## **Section 42A Report**

### **Report on submissions relating to Plan Change 78**

**Urban Estates Limited request to rezone approximately  
63.3 hectares of Rural (Inner Plains) Zone land at Lincoln-  
Rolleston Road and Selwyn Road in Rolleston to a  
Living Z Zone**

**13 October 2021**

Figure A: Recommended urban design amendments to the PC78 ODP Plan<sup>78</sup>

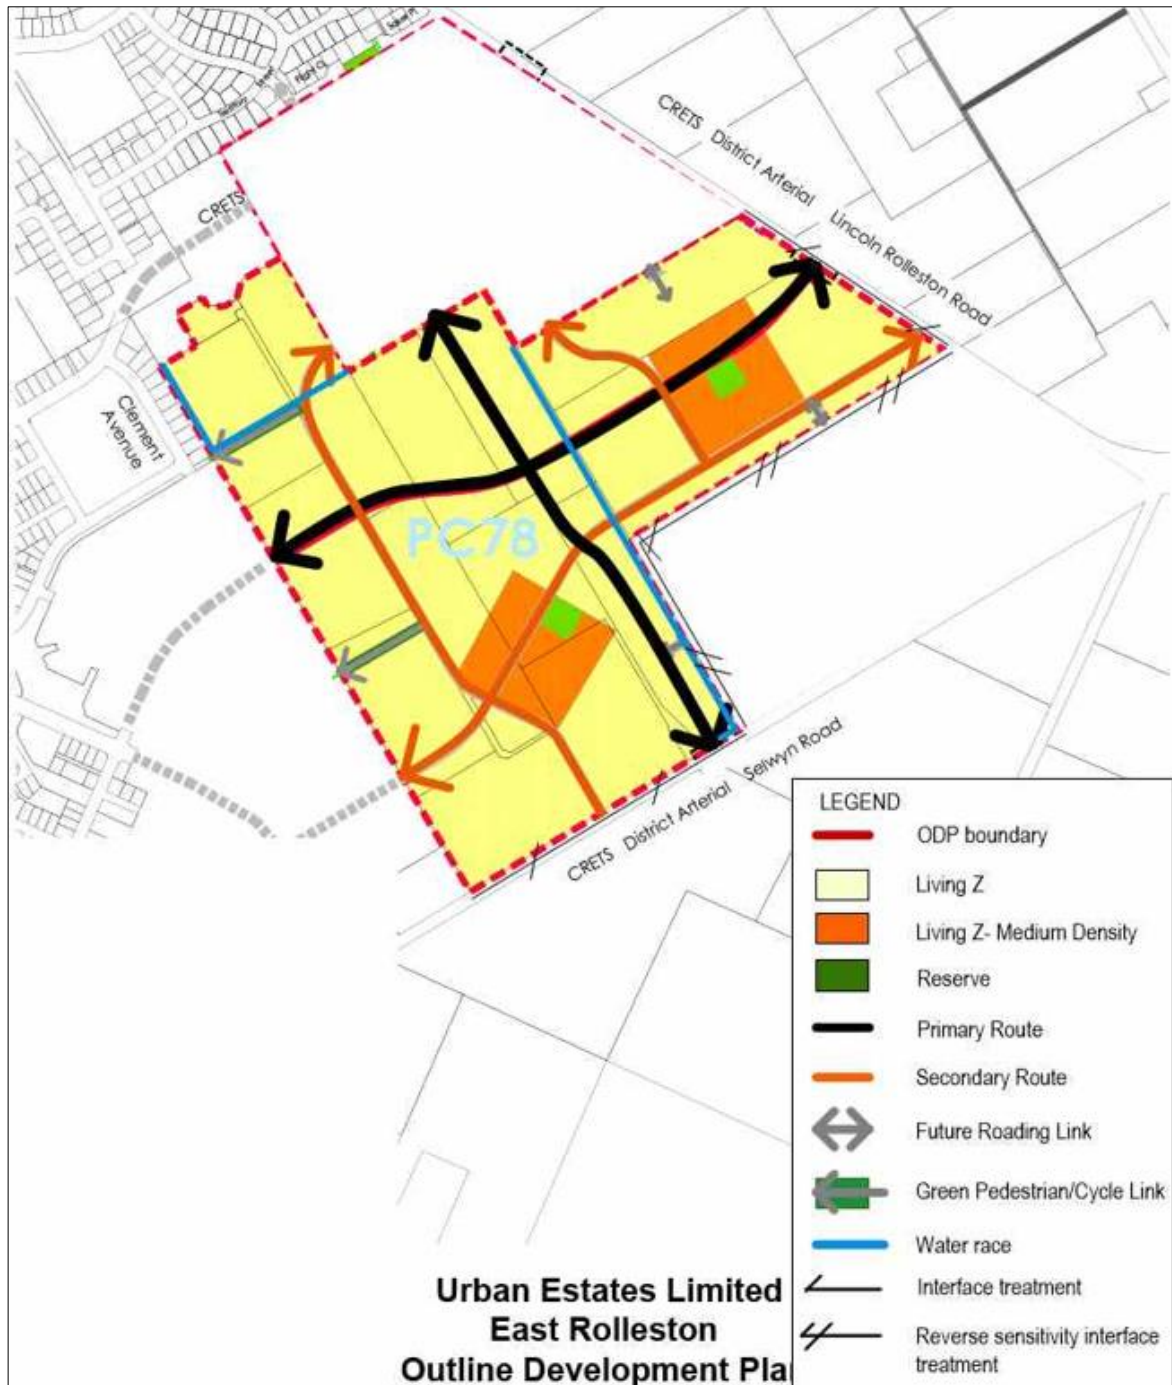
- 7.20. Ms. Wolfer's evidence has evaluated the rationale that has been applied by the plan change proponent to prepare the ODP. She has also undertaken an independent site analysis. This evidence indicates general support for the request, while including the following recommended changes to the ODP<sup>36</sup>:

- b. Amend the ODP to replace the indicative road references to 'primary route' and 'secondary route'.
- c. Amend the ODP plan and legend to replace the east to west aligned (CRETS) 'roading collector route' reference to a 'primary route'.

- d. Amend the ODP plan and legend to illustrate the future roading connections at the boundary of the site as 'double arrows'.
- e. Amend the ODP plan to remove the PC75 land and the property at the corner of Lincoln Rolleston Road and Selwyn Road, which do not form part of the PC78 site.

- f. Retain the 'secondary route' from the Acland Park subdivision through the PC78 site to Lincoln-Rolleston Road.
- g. Clarify and include a description in the ODP text demonstrating how the proposed reserve is linked with the surrounding green network, including a combined walking, and cycling network to key destinations, such as Te Rōhutu Whio Primary School. I also consider that the plan change proponent needs to clarify the catchments for the two reserves to ensure Council's minimum guidelines have been satisfied (500m to 600m radius).

7.22. I consider that it is appropriate that the plan change proponent incorporates these changes to the ODP to promote a safe and efficient road network that enables 'active' modes of transport and supports an integrated open space reserve network. These form part of my overall recommendation in Section 9 and the changes to the ODP Plan in Appendices 1 and 2.

Figure B: Recommended transport amendments to the PC78 ODP Plan<sup>79</sup>

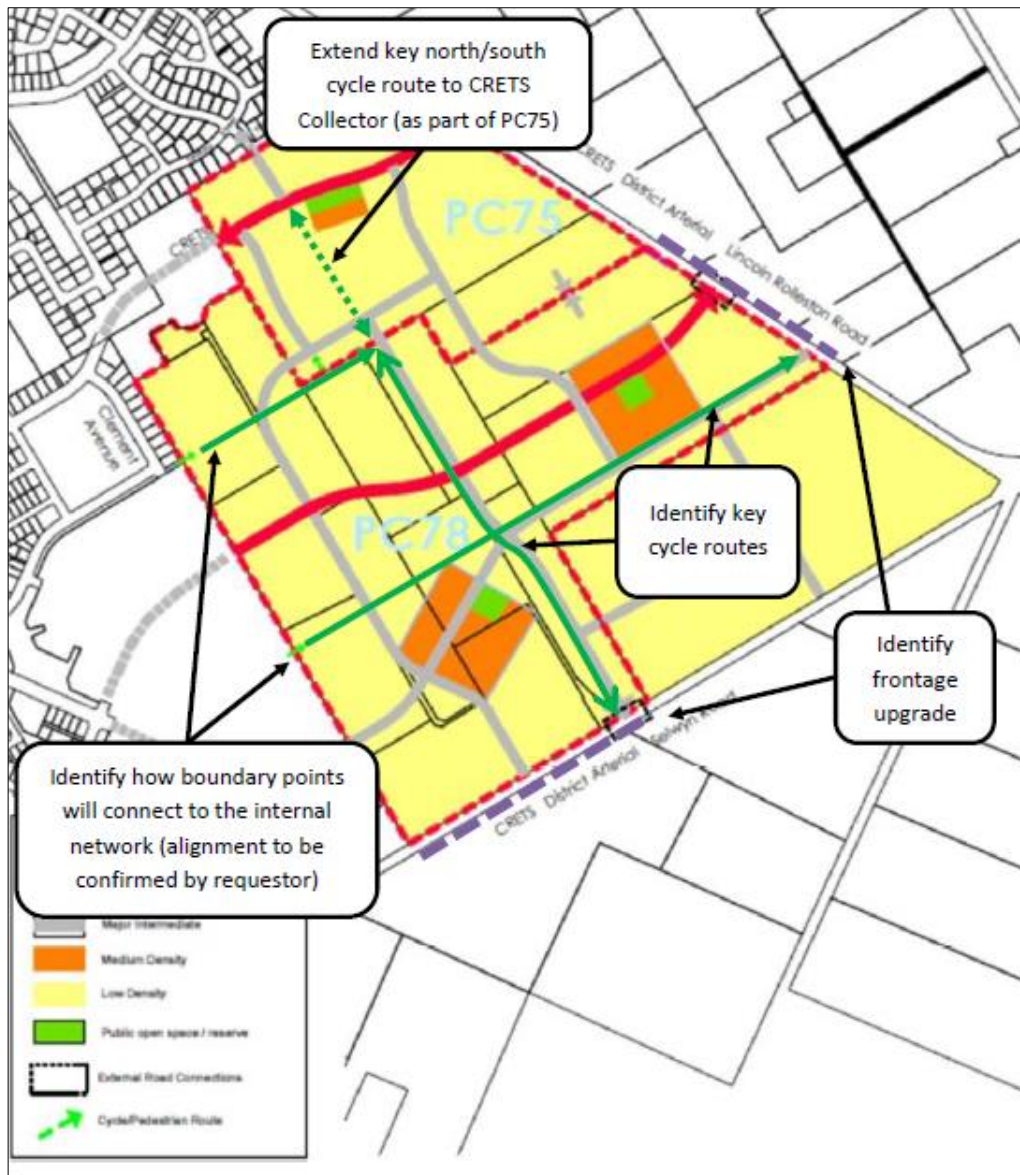
- 7.53. In respect of the Rolleston Structure Plan, Mr. Collins advises that PC78 is generally consistent with the Structure Plan, while noting that the CRETS Road has been realigned to extend through the PC75 site. He recommends that the PC78 ODP illustrates the primary north to south aligned

- 7.56. On the basis of the request and the evidence provided by Mr. Collins, I consider that PC78 will integrate with the wider transport network, avoiding any adverse effects on the safety and efficiency of this network. This is on the basis that Council will carry out programmed upgrades that would be funded through future Long Term Plan processes, with private plan change proponents/developers paying a proportional share of these costs at the time of subdivision by way of development contributions.
